Exhibit B

**EXHIBIT 1-1
RECOMMENDATIONS**

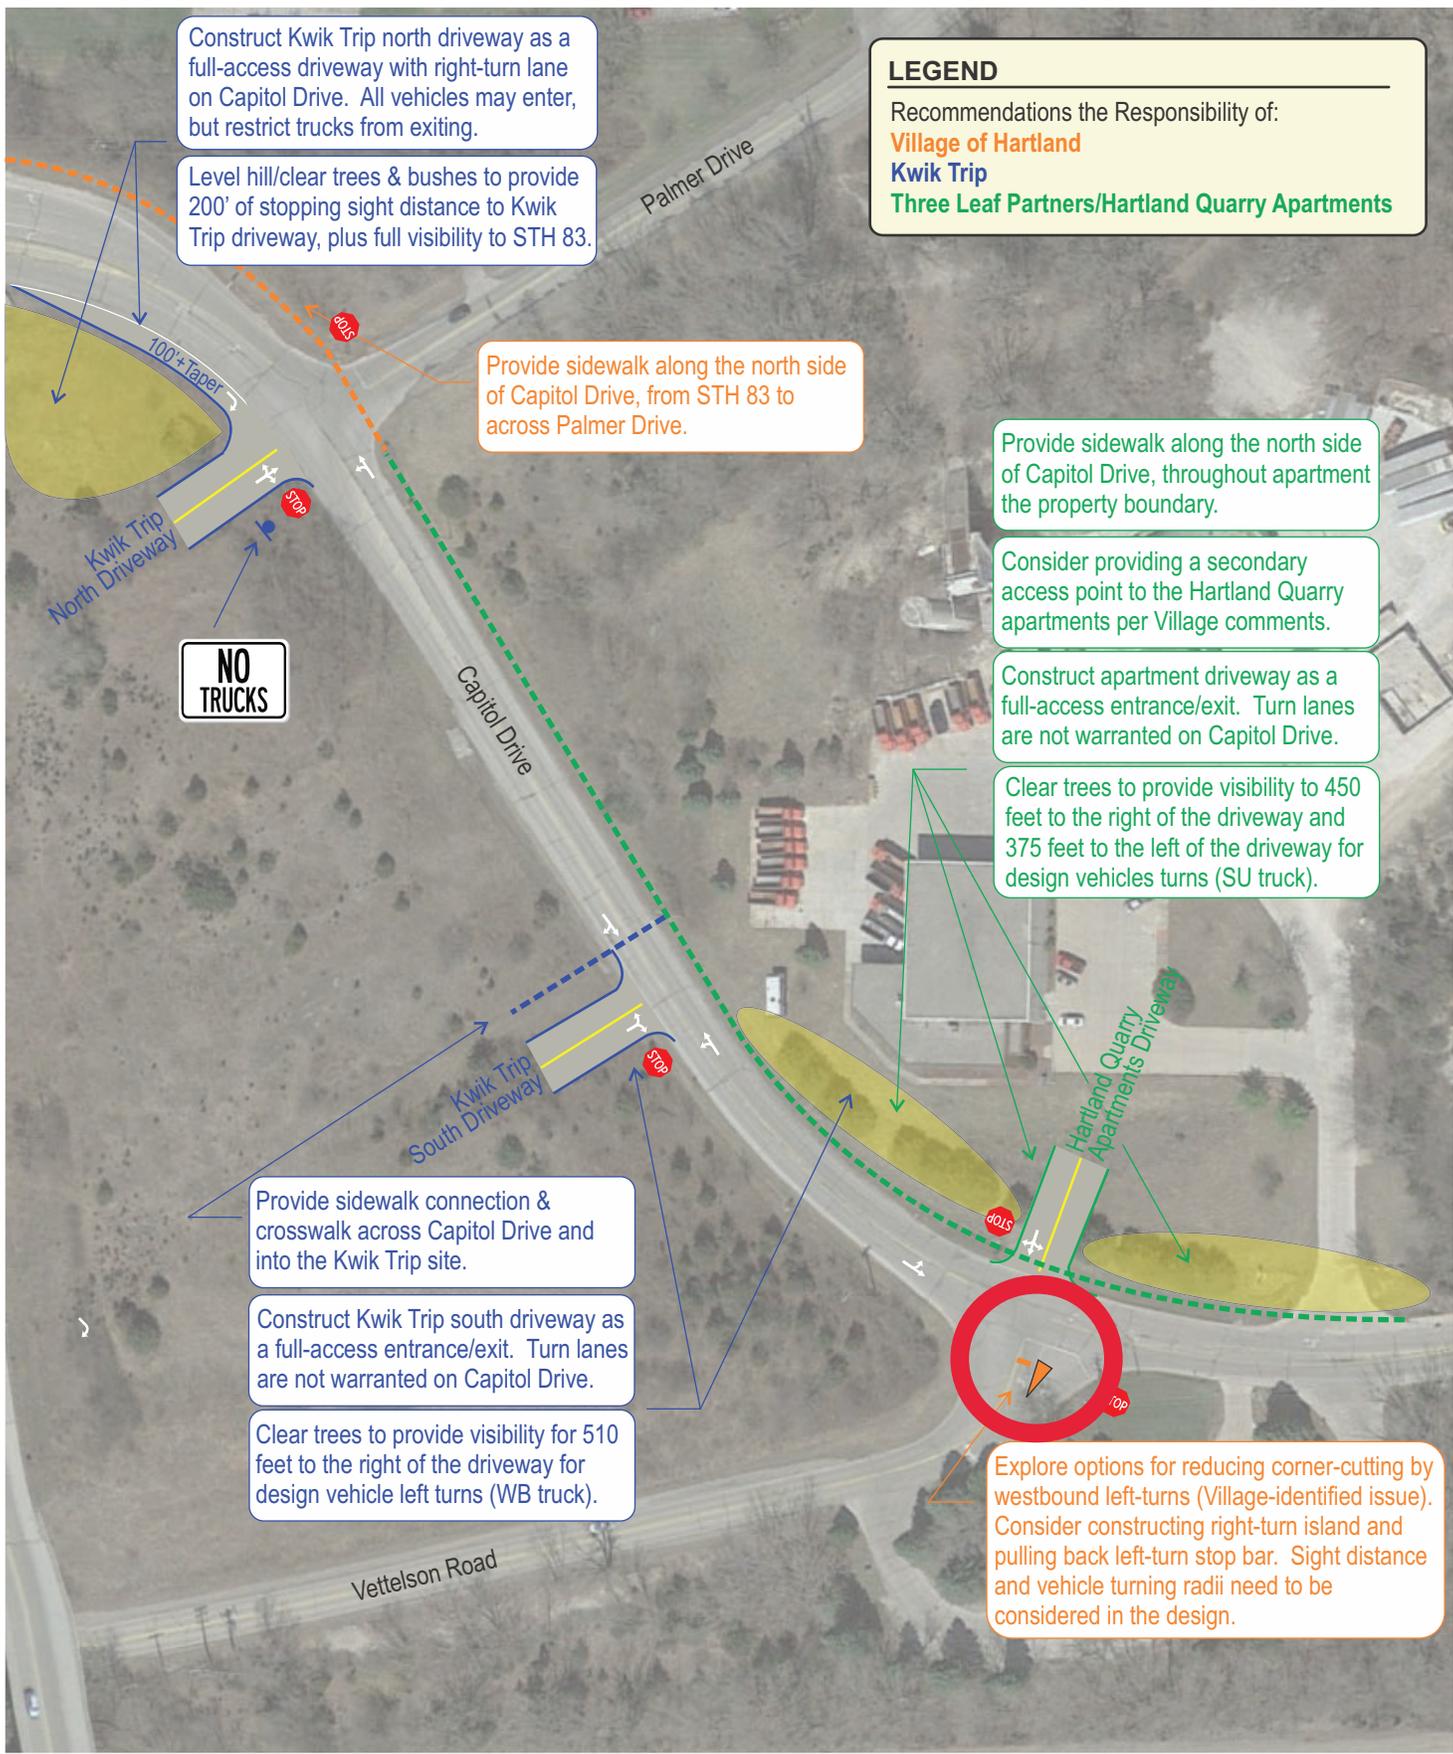
Construct Kwik Trip north driveway as a full-access driveway with right-turn lane on Capitol Drive. All vehicles may enter, but restrict trucks from exiting.

Level hill/clear trees & bushes to provide 200' of stopping sight distance to Kwik Trip driveway, plus full visibility to STH 83.

Provide sidewalk along the north side of Capitol Drive, from STH 83 to across Palmer Drive.

Provide sidewalk along the north side of Capitol Drive, throughout apartment the property boundary.

Consider providing a secondary access point to the Hartland Quarry apartments per Village comments.

Construct apartment driveway as a full-access entrance/exit. Turn lanes are not warranted on Capitol Drive.

Clear trees to provide visibility to 450 feet to the right of the driveway and 375 feet to the left of the driveway for design vehicles turns (SU truck).

Provide sidewalk connection & crosswalk across Capitol Drive and into the Kwik Trip site.

Construct Kwik Trip south driveway as a full-access entrance/exit. Turn lanes are not warranted on Capitol Drive.

Clear trees to provide visibility for 510 feet to the right of the driveway for design vehicle left turns (WB truck).

Explore options for reducing corner-cutting by westbound left-turns (Village-identified issue). Consider constructing right-turn island and pulling back left-turn stop bar. Sight distance and vehicle turning radii need to be considered in the design.
